PK Kiln Addendum

CHANGES TO KM1227PK & KM1231PK

There have been some slight modifications made to the KM1227PK and KM1231PK models since the last revision of the KM owners manual.

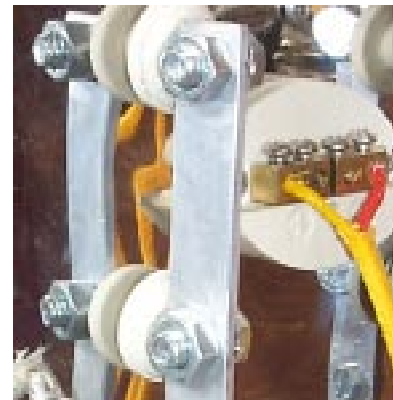
Replaced screw on element connectors with more convenient element busbar system.

Disassembling KM1227PK and KM1231PK Kiln Sections

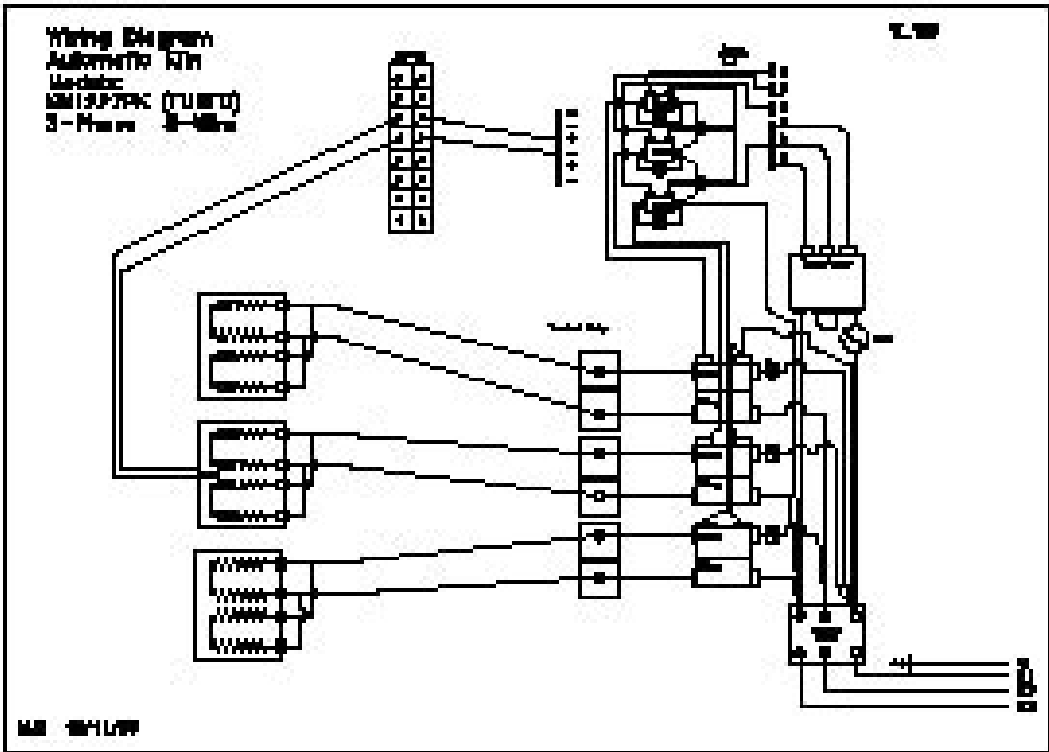
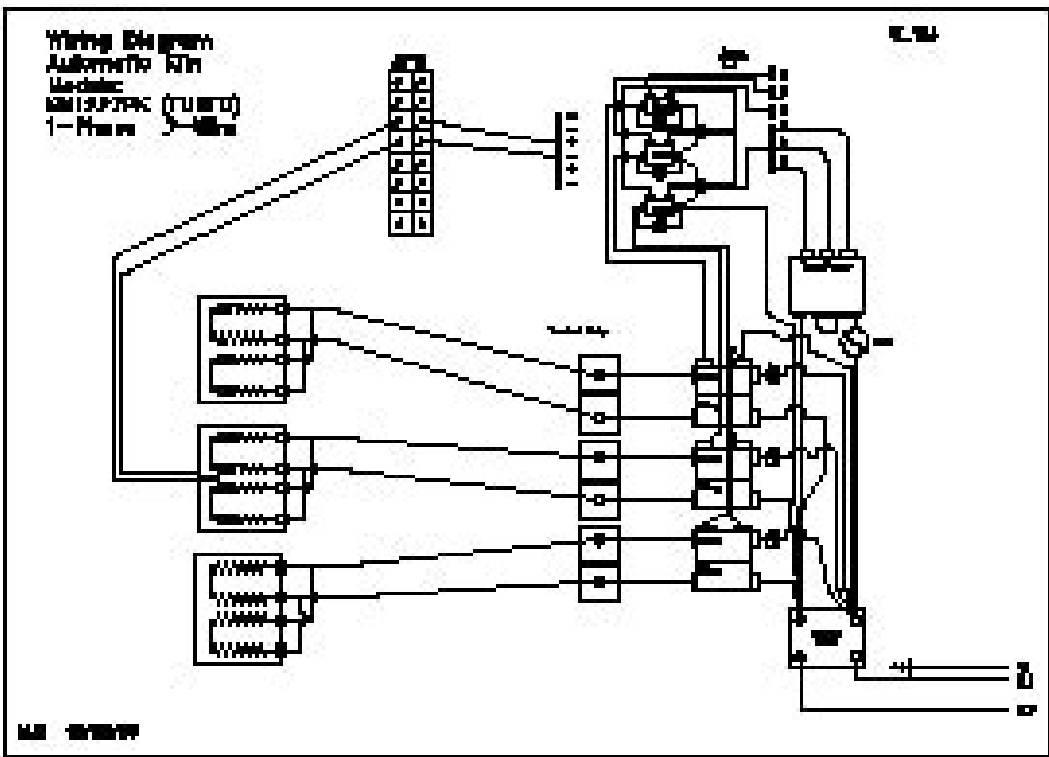
Changed style of feeder wire pole blocks for easier maintenace

3   Remove the screws holding the feeder wires to the two pole blocks on the heat baffle. There are three sets with two feeder wires going into each set.

3   Reattach the feeder wires to their corresponding block. Make sure the connection is very tight to avoid electrical problems.
